Development Referral No. DN26/0002

Proposal: Modification seven - Infrastructure consolidation and remediation works

Property: 160-166 Captain Cook Drive, Kurnell

Council Mapping extract showing the mapped biodiversity values lands, being wetlands, their 100m buffer zones, which works are proposed.

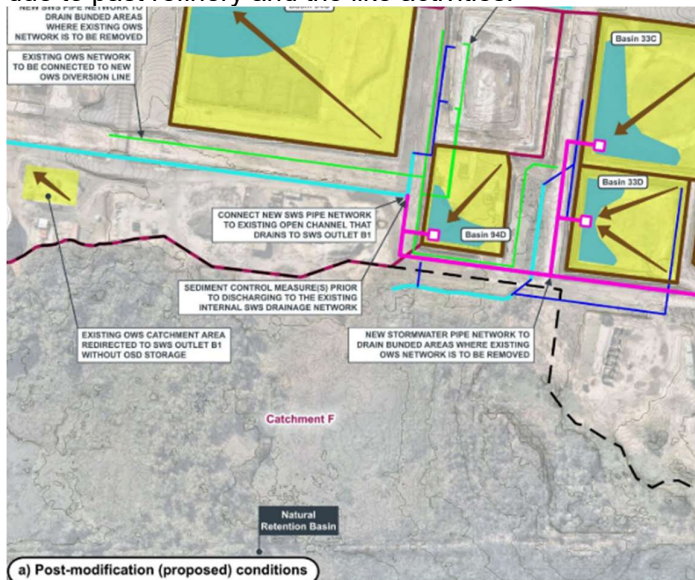
- b) On page 128 in Section 4.13.8, a comment is made regarding that Appendix I (Updated BDAR) which concludes *that no impacts to coastal wetlands would occur with the application of additional mitigation measures outlined in Appendix G and thus no further assessment of potential impacts to coastal wetlands from stormwater flows or surface water quality is required. Additional assessment on potential impacts to coastal wetlands as a result of groundwater impacts is provided in Section 4.2.4.*

This is not agreed as the application proposes works through a wetland rather than propose an alternative which avoids all works in and through wetland areas.

This comment infers a reactionary rather than a precautionary approach. It is acknowledged that an impact cannot be fully avoided, however, council advises that works in and through wetlands must be avoided, particularly as there is large tracts of land that are not mapped as being environmentally sensitive available where infrastructure and the like can be constructed and installed, to minimise impacts.

Extract of Figure 5-5 showing the reliance on the drainage swale constructed without approval and through a mapped wetland.

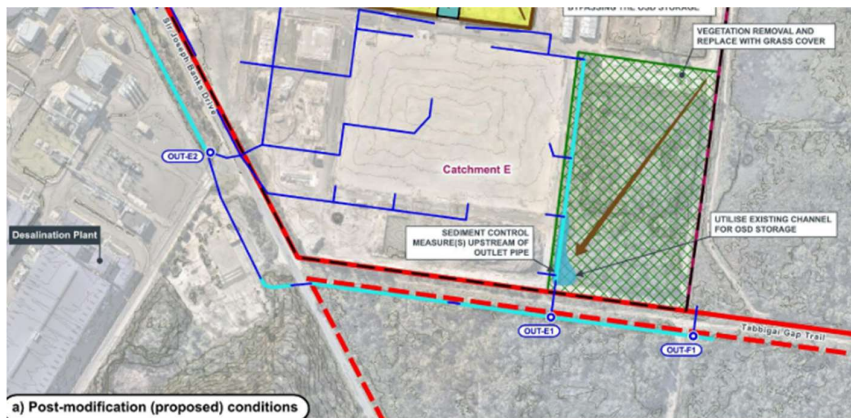
- a) Pages 124 and 125 of the Submissions Report responds to the issue raised regarding the unauthorised construction of a rock lined stormwater channel. A review of historic aerial photography has revealed that a depression has existed in this area, since circa 1978, but the fact remains no development consent was granted for the enlargement of this drainage channel, for ecosystem health and/or erosion preventative measures as claimed.

In accordance with SEPP Resilience and Hazards 2021 (RHSEPP) and the Biodiversity Map that supplements the Biodiversity and Conservation Act 2016, the rock lined channel traverses a mapped wetland area. In accordance with Section 2.7(2) from RHSEPP, designated development would have been triggered for the works.

It is drawn to the Department's attention that in Council's previous response, '(t)he future development of land must not rely on the unauthorised drainage channel for any stormwater disposal and the like. Ideally, the channel and all associated works must be removed and the land restored to pre work conditions. A long-term vegetation and land restoration management plan should accompany any future application for the restoration of the wetland environment.'

The modification application must investigate alternate drainage requirements should council refuse the BIC.

Extract of Figure 5-6 from Appendix G, showing infrastructure proposed adjacent to a southern access road towards Sir Joseph Banks Drive.

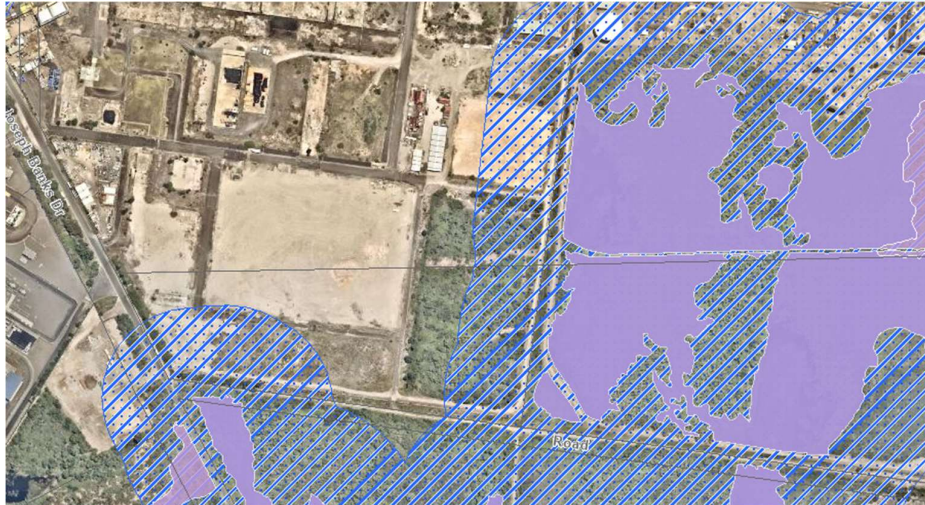
- a) While not highlighted in our previous submission, to offset the loss of vegetation throughout the site and particularly on the RPIP Mountain, council recommends that a covenant on title is created in accordance with Section 88 of the Conveyancing Act 1919 requiring the lands within Zones 4 and 5 be retained in perpetuity as conservation areas of high ecological significance.
- b) Figures 5-5 and 5-6 from Appendix G Updated Surface Water, Wastewater and Flooding Report shows OUT-F1 and OUT-E1 (attached below) and a surface water open channel will be constructed within Zone 5 and significant environmental concerns are raised – refer to extract below.

As highlighted in the previous submission, proposed works within Zones 4 and 5 must not occur to preserve these areas of high ecological significance. There is nothing preventing the installation of drainage controls, the construction of roads, installation of services and the like on already disturbed lands having little to no ecological significance due to past refinery and the like activities.
